**Planning Application under Section 16 of Town Planning Ordinance for
Public Utility Installation (Radio Base Station) and Excavation of Land on Government
land, near Lin Ma Hang Road, Lin Ma Hang, New Territories**

Supporting Planning Statement

**Re: Proposed Installation of Mobile Radio Base Station and Antennae at
Lamp-post Sites at Frontier Closed Area, Ta Kwu Ling, N.T.
(Applicant: SmarTone Mobile Communications Limited)**

Drawing Title: Photos for Site 2 & 3

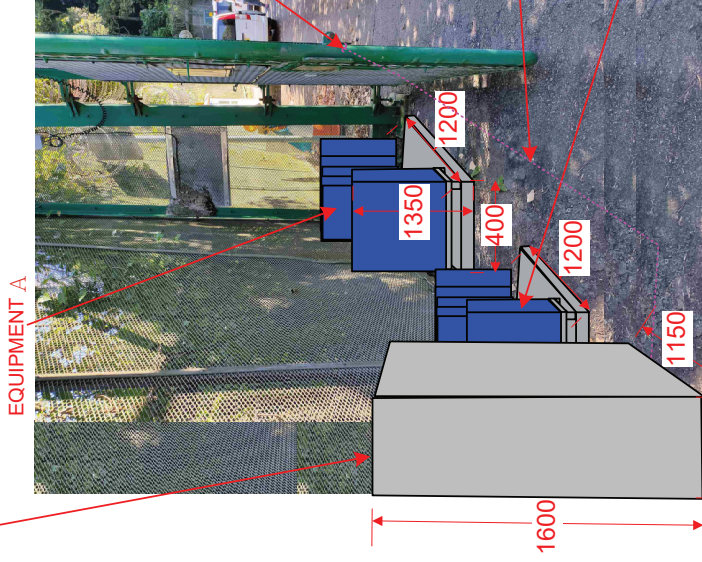
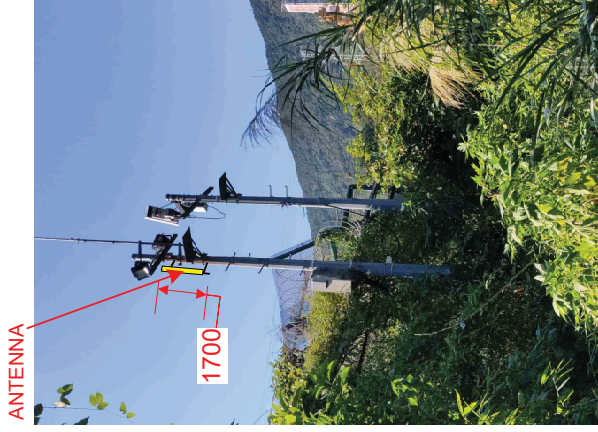
4. Based on the information provided by you, the proposed roadside equipment cabinets and meter kiosks (Drawing Nos. B8435-S11 to B8435-S13) do not fall within the specified limitation/requirement of telecommunications radio base station mentioned above, which is to install within, attach to or on the roof top of a building or structure, hence they are regarded as 'Public Utility Installation' requiring planning permission from the Town Planning Board (the Board). You are advised to critically review the project programme and allow sufficient time for pre-submission circulation to all relevant Government departments' prior formal submission to the Board. For making planning application under Section 16 of the Town Planning Ordinance, please refer to the following link for necessary reference: https://www.info.gov.hk/tpb/en/forms/Guidance_Notes/S16_GN_ENG_Feb%202021.pdf.
